To replace Epia ML Motherboard with VB7009

To replace Epia M830 Motherboard with VB7009

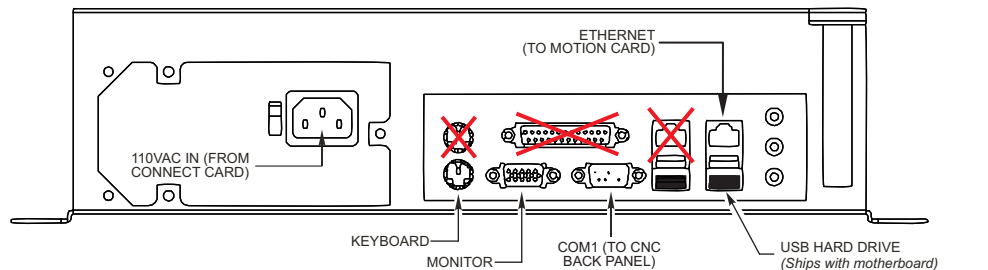
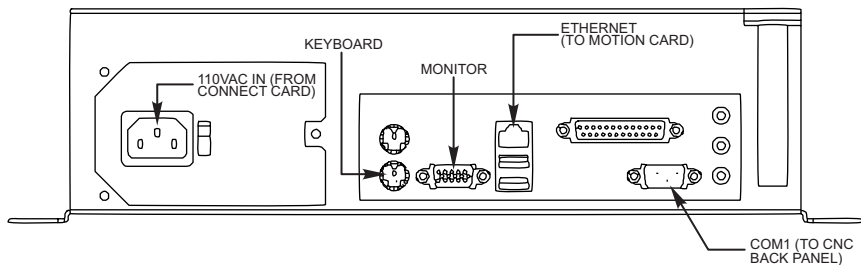
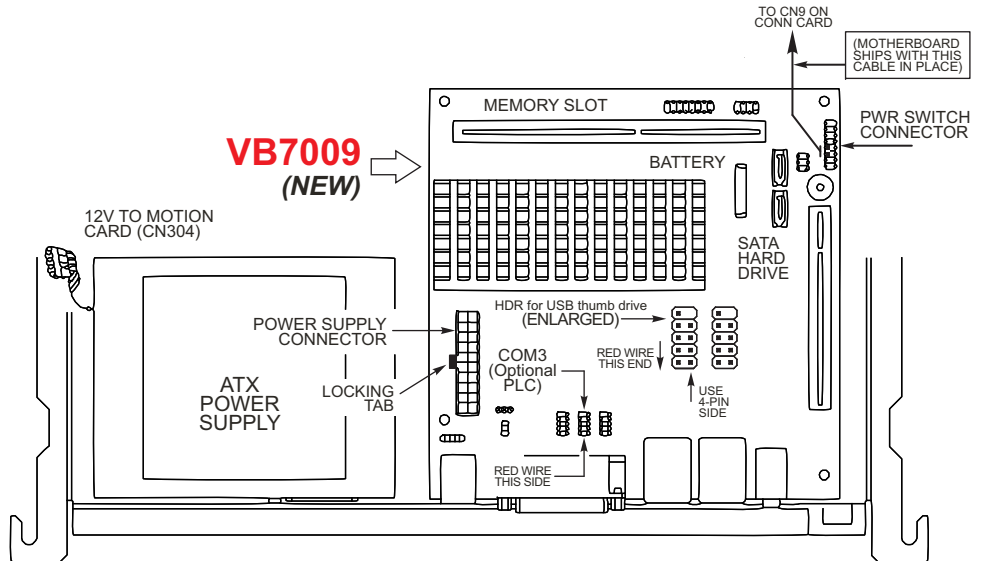
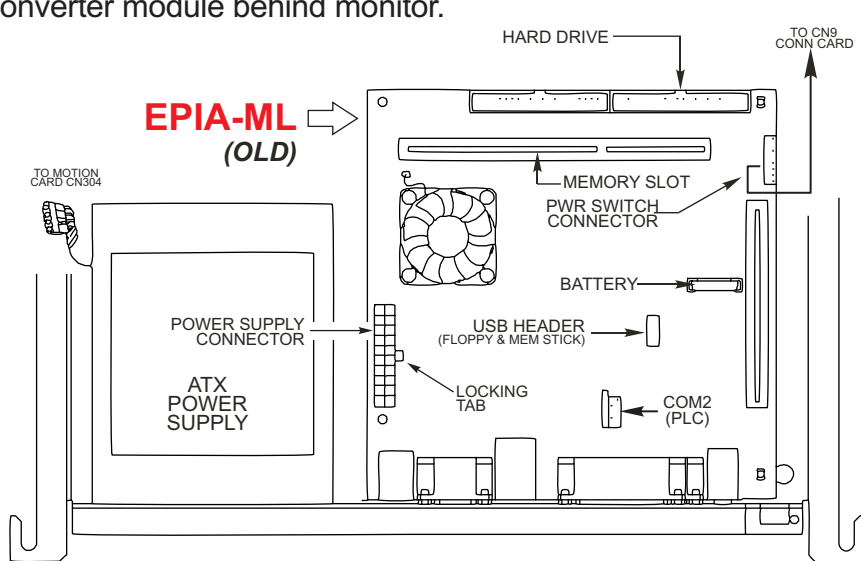
HARD DRIVE: The IDE hard drive ports have been replaced with SATA, so your existing hard drive will not work. *The VB motherboard ships with a USB hard drive pre-installed, configured for your system.*

POWER CONNECTOR: Note that the locking tab is reversed on VB.

COM2: If you have ribbon cable at COM2 (PLC) on Epia ML, you will need 2.5mm -2mm adapter. Install cable and adapter at COM3 on VB7009, red stripe toward front. Route this cable to the RS422 converter module behind monitor.

USB HEADER: If you wish to continue using floppy for backup, you must release the floppy disk while CNC boots up, then push it in to backup your program files. Probably better to use USB for backup.

PWR SWITCH CONNECTOR: Motherboard is shipped with cable connected to this header. These connections are unchanged from ML to VB, so you may wish to remove the cable at the header and use your existing cable. Otherwise, route this cable to CN9 on connect card and discard your original cable.

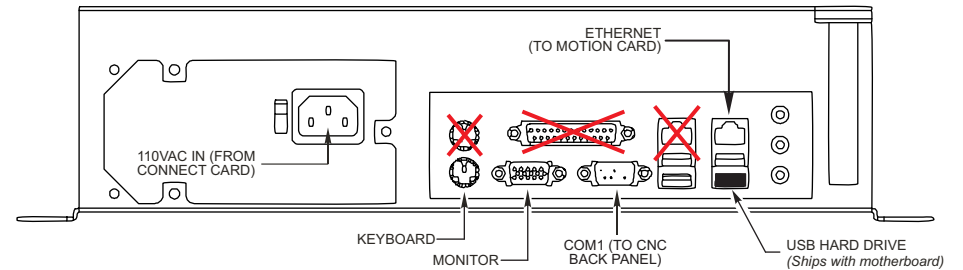
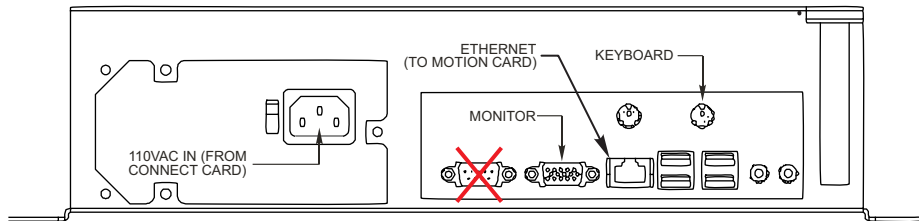
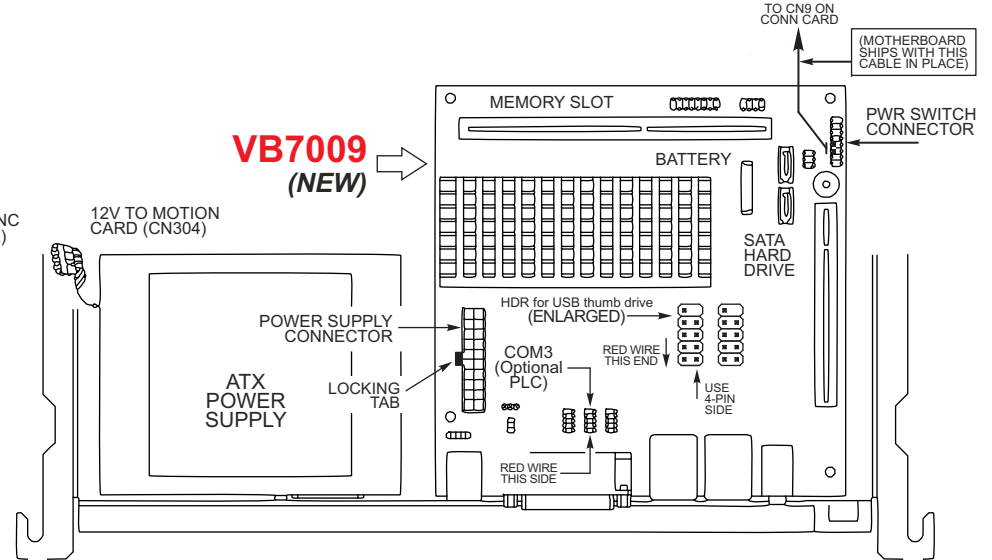
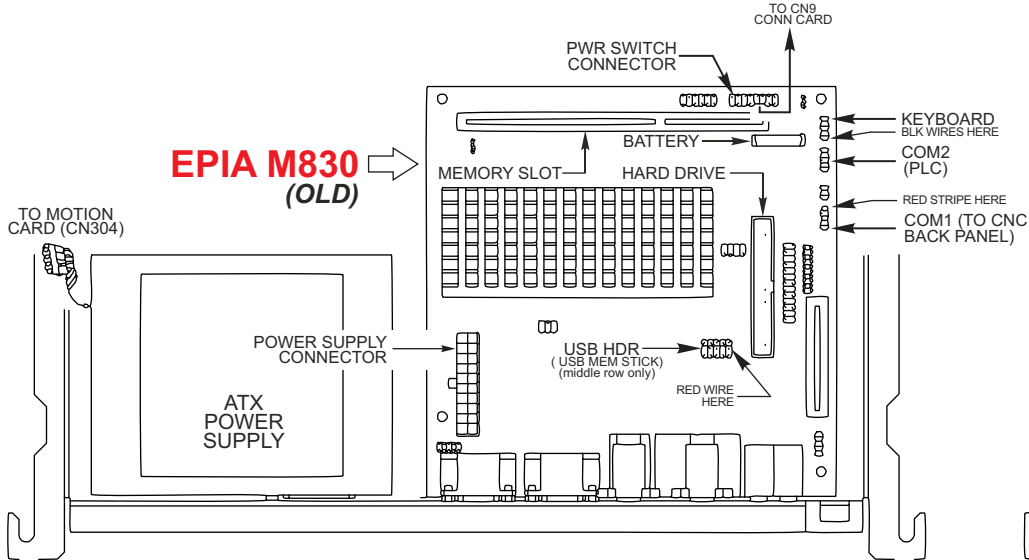
HARD DRIVE: The IDE hard drive ports have been replaced with SATA, so your existing hard drive will not work. **The VB mother board ships with a USB hard drive pre-installed, configured for your system.**

PWR SWITCH: Moved from back to right side. Motherboard is shipped with cable connected to this header. These connections are unchanged from M830 to VB, so you may wish to remove the cable

at the header and use your existing cable. Otherwise, route this cable to CN9 on connect card and discard your original cable.

COM1: The 10-pin ribbon-cable from header on mother board must be replaced with cable provided. Connect 9-pin female to COM1 connector on computer panel; route 9-pin male to CNC rear panel.

COM2: If you have ribbon cable at COM2 (PLC) on Epia M830, move that cable, including adapter, to COM3 (PLC) on VB7009. Red stripe goes toward front.
